Detailed Site Plan Terrapin House

DSP-22035

REQUEST	STAFF RECOMMENDATION
One mixed-use building with 93 multifamily dwelling units and 4,800 square feet of ground-floor commercial space.	APPROVAL with conditions

SUBJECT: Detailed Site Plan DSP-22035
Terrapin House

Figure 1: Site Plan

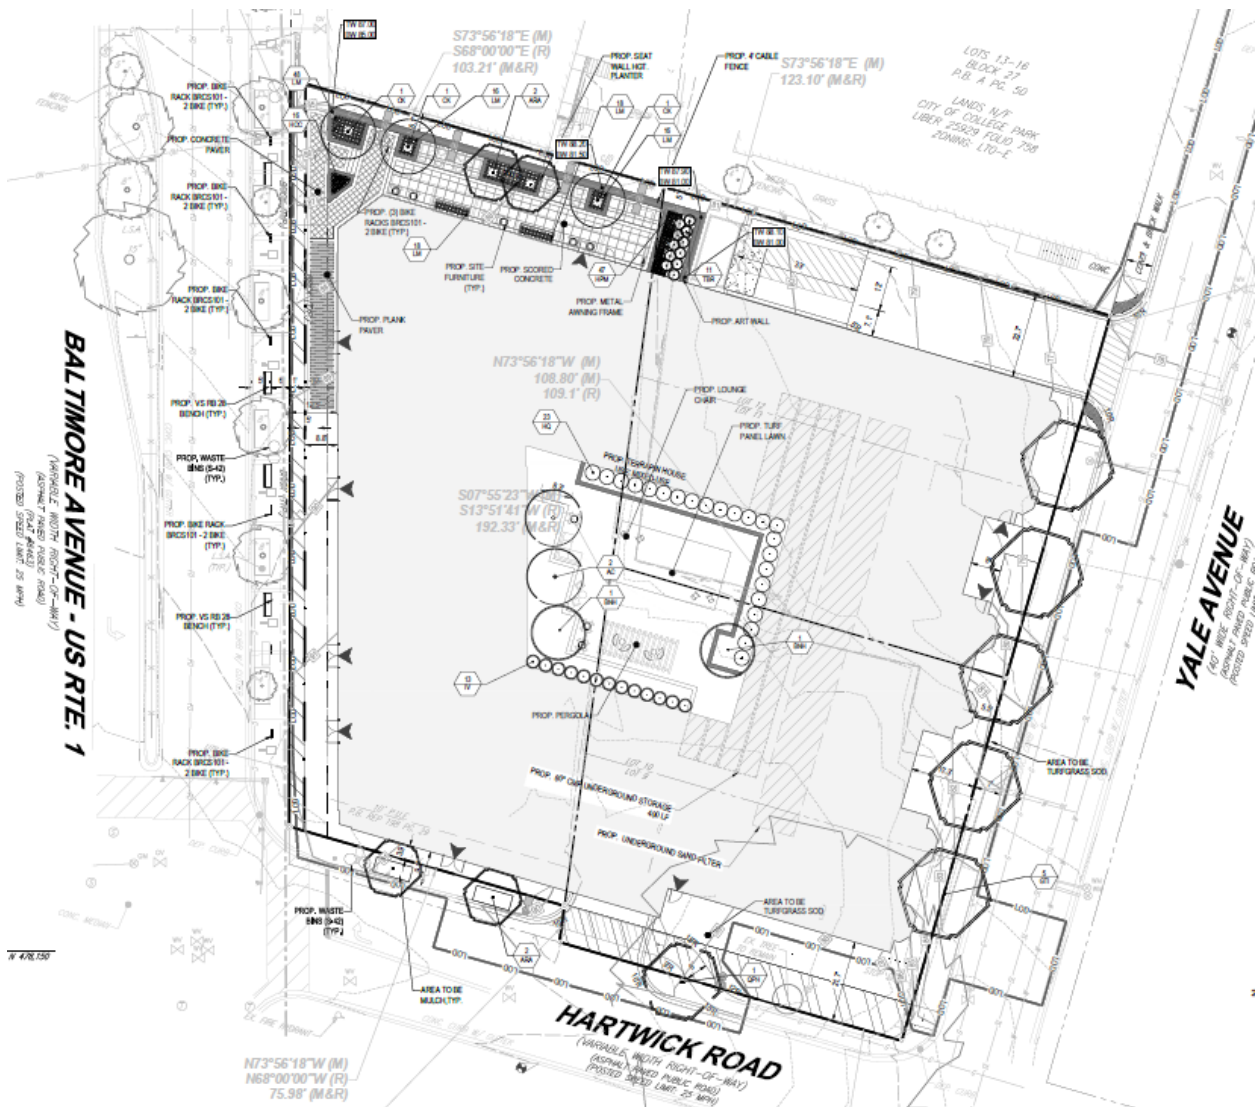
Improved sidewalks are shown along all frontages of the site. Crosswalks are shown, crossing the drive aisle at both points of vehicle access; thereby, connecting gaps in the sidewalk network, while bringing attention to motorists that pedestrians may be crossing. The frontage of US 1 will be improved, with a 10-foot-wide sidewalk and a 6-foot-wide bicycle path, per the recommendations of the sector plan. Street trees, lighting, benches, bicycle racks, trash receptacles, and a 5-foot-wide landscape strip with plantings are also proposed, along the main streetscape of US 1. In addition, sidewalks are provided along Hartwick Road and Yale Avenue for the enhancement of pedestrian connectivity.
